### **Downtown Carpark Redevelopment (BUN60435935) – Response to Further Information Requests**

This letter addresses the request for further information request received on 23 September 2024.

**Table 1: Section 92 response**

Figure 1. H8.6.24.1 Maximum tower dimension standard.

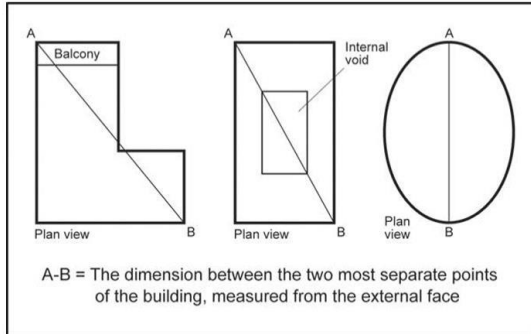
<p><b>H8.6.24. Maximum tower dimension, setback from the street and tower separation</b></p>	
57	<p><u>Maximum tower dimension:</u> Pages 37-38 of the Urban Design Assessment report, state the diagonal dimension of 50.64m for Tower 2. However, it should be measured from the most separate points as shown in Figure H8.6.24.1 below, which is the western façade of the building, which is 50.95m. This additional dimension may seem minimal but the western façade presents some of the most imposing architectural forms.</p> <p>a. Please can the Urban Design Assessment, Rules Assessment and AEE be updated to state the correct dimension.</p>
	<p>The maximum tower dimension has been updated in the Urban Design Assessment including an assessment of the infringement as it relates to T2.</p>

b. The Urban Design Assessment report does not include Tower 2 in this specific section and concentrates only on T1. Please can the Urban Design Assessment Report be updated to provide assessment of Tower 2 for this Standard.

Figure 2 – Figure 2.30 from the Urban Design Assessment.

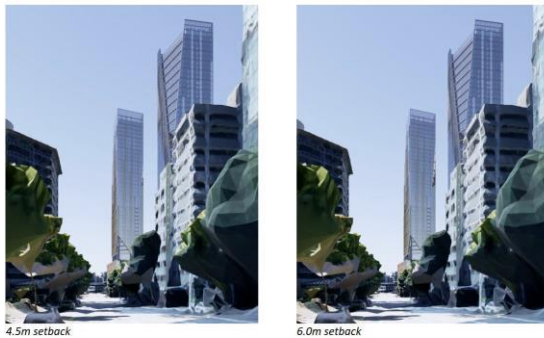
58 Tower setback: For Tower 2, a comparative diagram was included on page 40 of the Urban Design Assessment report with two versions, one with a 4.5m setback and the other with the required 6m setback from Lower Hobson Street. However, the chosen view angle is quite distant to assess the street experience, and the resolution and the level of detail of these diagrams are quite low (Figure 2 below illustrates this). To better inform the assessment of effects, please provide the following to demonstrate how the proposal achieves a consistent human-scaled edge to the street:

Figure 3. Requested view locations related to tower setback comparison.

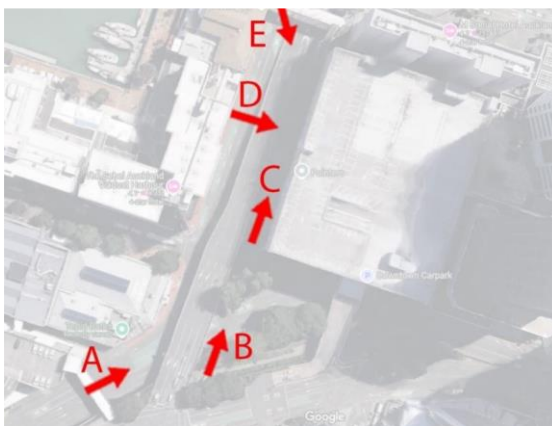
- i. a more detailed analysis regarding this reduced setback be provided; and
- ii. additional model render views at a higher resolution based on the series of locations identified in Figure 3 below;
- iii. technical section comparison drawings to assist this assessment being detailed cross-sections at 1-100 or similar scale that include the full extent of the road reserve, kerb line, pedestrian footpath of both sides and the landscape elements on the podium level dimension for both 4.5m and 6m deep profiles. Please include people in the drawings to illustrate the outcomes achieved concerning the human-scale.
- iv. At the pre-application stage, a viewpoint was requested from the corner of Hobson Street and Fanshawe St looking toward the north-east. An updated version of this visual simulation would be helpful for the assessment of the effects of not

Figure 1

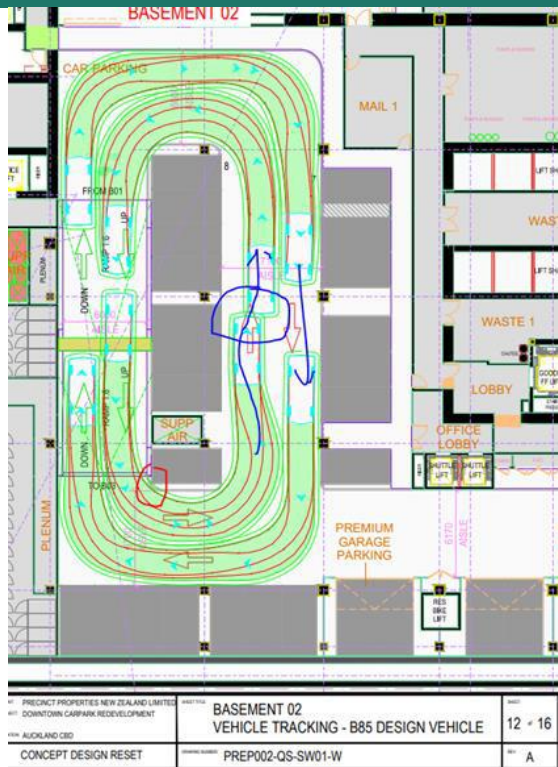
<u>Car Parking</u>		
136	<p>Access and Maneuvering (E27.6.3.3). The Vehicle Tracking assessments are provided as Appendix E of the Traffic Report. Sheet 12 of 16 Basement 02 Vehicle tracking – B85 Design Vehicle (Drawing number: PREP002-QS-SW01-W Rev A) with snip copied below (Fig 1) shows a clash with a structure (identified with the red circle). The blue annotation below illustrates a segmented / non-continuous tracking curve. Please provide tracking curves that are continuous and do not clash with structures.</p>	<p>The areas identified in the request are not structures, but flush markings only. Vehicles will be able to drive over these areas without conflicting with a structure.</p> <p>Updated vehicle tracking are provided in Appendix E, which provides continuous vehicle tracking as requested.</p> <p>It is confirmed that no changes to the layout are necessary due to this information request.</p>

Figure 2

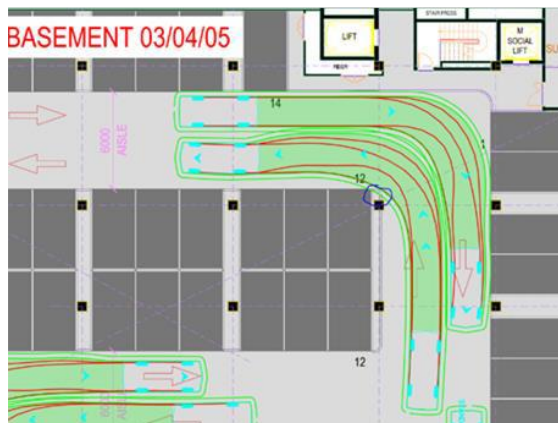
137 Sheet 14 of 16 Basement 03/04/05 Vehicle Tracking – B85 Design Vehicle (Drawing number: PREP002-QS-SW01-W Rev A) with snip copied above (Fig 2) shows the tracking curve clearance clashing with a structure. Please amend the tracking curves or identify design changes that provide mitigation for this clash.

As with response to item 136, these are flush line markings and not solid structures. Therefore, vehicles will be able to drive over these areas if necessary without creating a conflict.
